To: Town of Rolesville
From: Tyler White, P.E., Kimley-Horn
Date: September 29, 2023
Subject: CID-23-07 Parker Ridge Young St. Off-site – Comment Responses

The following comments were provided by the Town of Rolesville via the Town review portal on August 2, 2023:

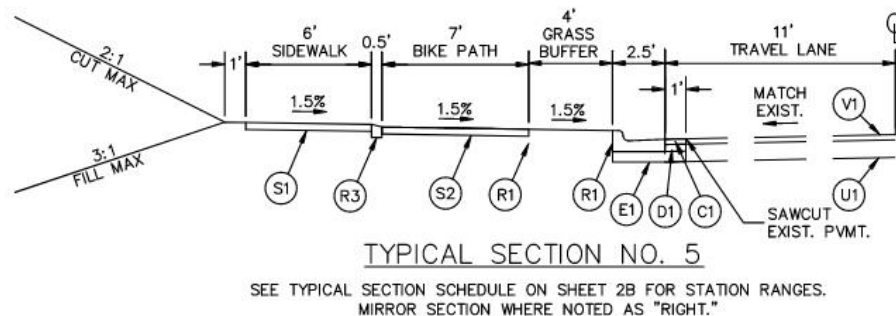
- The Town's Bicycle and Greenway Plans identify a Bike lane within the travel lanes, and a Sidepath outside the travel lanes/within the Right-of-way, of E. Young Street, respectively. Please revise to show both of these non-vehicular pieces of the infrastructure or explain why they cannot be provided. For a single reference see page 5 and 70-71 of the Bike Plan, which represents both: https://www.rolesvillenc.gov/sites/default/files/uploads/rolesville_bikeplan_final_appendices_august2022.pdf

Response: Additional discussion on this comment with Town staff occurred at the scheduled TRC meeting on 8/10/2023. It was discussed that both the requested bike lane and sidepath cannot be provided at this time due to right of way constraints since these design elements would require both permanent right of way and construction easement from adjacent properties for construction. In addition placing the additional asphalt for an onstreet bike lane would place the proposed curb line at a location where additional utility conflicts with the proposed storm drainage and the existing waterline and force main are anticipated. Our recommendation is for the Town to implement a future raised bike lane behind the curb line to avoid additional utility conflicts along E Young Street similar to what is show in the below typical section for reference.
